Columbia River Inter-Tribal Fish Commission
729 N.E. Oregon St. Suite 200
Portland, OR 97232

April 30, 2000

Department of the Army
Walla Walla District, Corps of Engineers
ATTN: Lower Snake River Study
201 North Third Avenue
Walla Walla, WA 99362-1876

The Columbia River Inter-Tribal Fish Commission (hereinafter "Commission" or "CRITFC") appreciates this opportunity to provide comments on the Lower Snake River Juvenile Salmon Migration Feasibility Report/Draft Environmental Impact Statement (December 1999). The Commission is composed of the the Fish and Wildlife Committees of the Confederated Tribes of the Umatilla Indian Reservation, the Confederated Tribes of the Warm Springs Reservation of Oregon, the Confederated Tribes of the Yakama Nation, and the Nez Perce Tribe. These four tribes possess rights reserved by treaties with the federal government to take a fair share of the fish destined to pass their usual and accustomed fishing places. Among these fish are the anadromous species that originate in the Columbia River and its tributaries.

1994 weekly average spring chinook and hatchery steelhead passage indices,
and spring chinook SARs

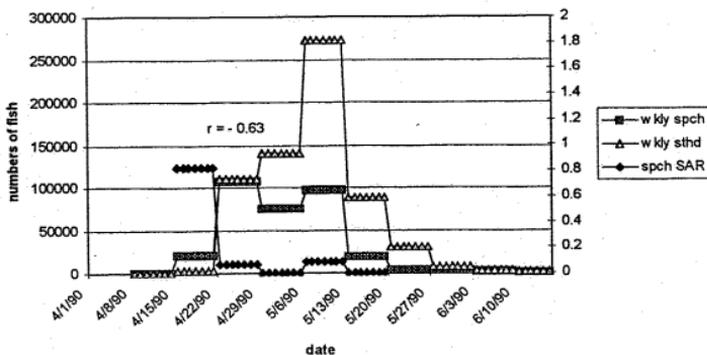
Regardless of steelhead abundance, transported spring/summer chinook survived at low rates. Only in three weeks within the six years did the SARs meet or exceed one percent. Note that these SARs are from Lower Granite Dam only where transport survival is typically the highest. Lower dams such as Lower Monumental and McNary, if added to this type of analysis, have historically show even lower SARs for chinook.

While it is certainly realistic to suspect that hatchery steelhead could consume, injure or at least stress the smaller spring/summer chinook, these results indicate that even the total elimination of the steelhead hatchery program would not result in the restoration of spring/summer chinook to the level of survival (approximately two percent), far less recovery (approximately four percent.) Thus while hatchery steelhead likely contribute to the poor performance of spring/summer chinook, there are clearly other contributing factors and these other factors appear to pose greater limitations to chinook survival and recovery than hatchery steelhead.

1992 spring chinook SARs versus ratio of hatchery steelhead to spring chinook passage indices

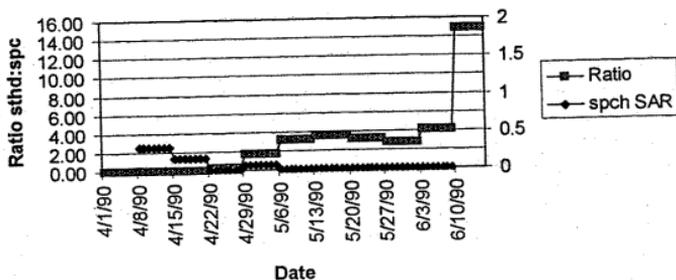
Visual observations provide no relationship between spring/summer chinook survival and hatchery steelhead abundance. There are periods of low steelhead abundance with extremely low chinook SARs as well as periods of relatively high steelhead abundance accompanied by relatively high chinook SARs. Correlation coefficients also indicate that the relationship between hatchery steelhead abundance and spring/summer chinook survival is poor. Correlation coefficients were weak and only half showed the negative relationship that would be expected if hatchery steelhead were the cause of poor chinook survival.

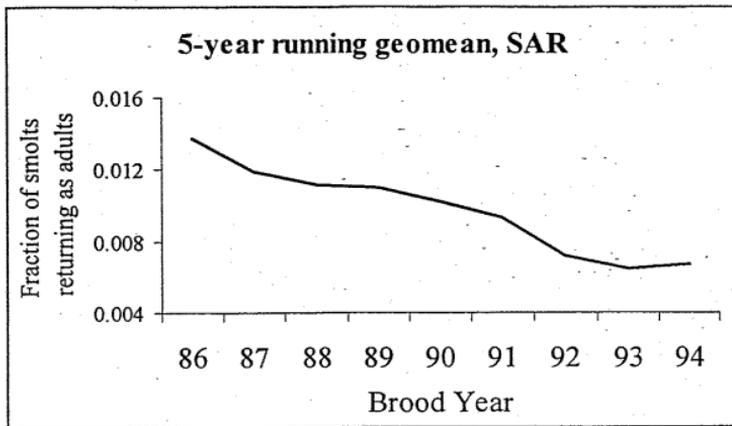
The net result of direct and delayed migration effects, as well as the rigors of ocean survival itself, is that since 1980, on average, less than 1 out of 100 outmigrating juveniles has been making it back to the river mouth, and the rate has overall been in decline (Figure 3). In recent years, the average SAR has been about 5/1,000. Today these returnees suffer another 50% or so

reduction in numbers migrating back up the Columbia River and lower Snake River to their spawning grounds. Historically 3 to 5 smolts made it back to the Columbia River mouth as adults.

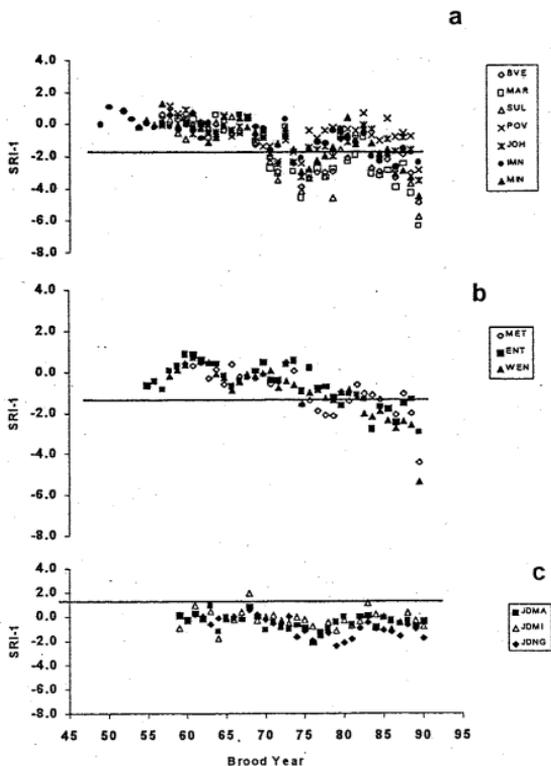
If travel distance were the reason that upper Columbia River and Snake River stocks are in worse trouble than lower Columbia River stocks, then historical data would show this pattern. And there would be some plausible way to explain the pattern developing only after the hydrosystem was completed, not before. If anything, upriver stocks were historically more productive than downriver stocks, not less (Figure 5).

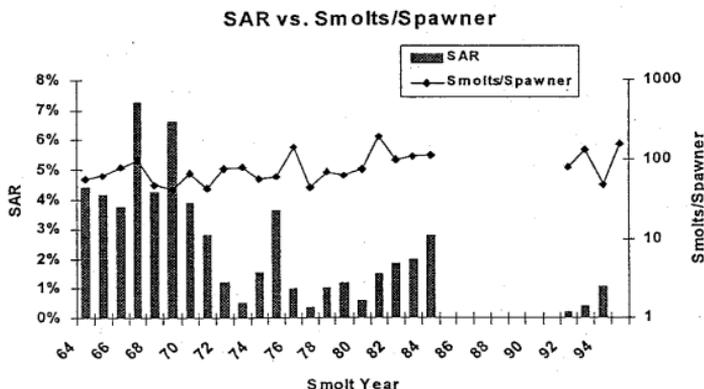
represented by smolt-to-adult returns (SAR). Figure 7 shows that what changed for Snake River spring and summer chinook after the dams were completed was the SAR survival rate, not the egg-to-smolt (freshwater) survival rate.

Downstream migration and delayed mortality are included in SAR, and so the analysis summarized in Figure 7 supports the contention that it is not freshwater habitat that is somehow the cause of delayed mortality, nor of the decline of Snake River spring and summer chinook.

257
cont. hatcheries or harvest were the driving mechanism behind delayed mortality, then it would be necessary to explain how hatcheries or harvest impacted upriver stocks more than downriver stocks, or transported fish more than in-river fish. It is also unlikely that hatchery effects would have affected only smolt-to-adult survival but not egg-to-smolt survival, as indicated in Figure 7.
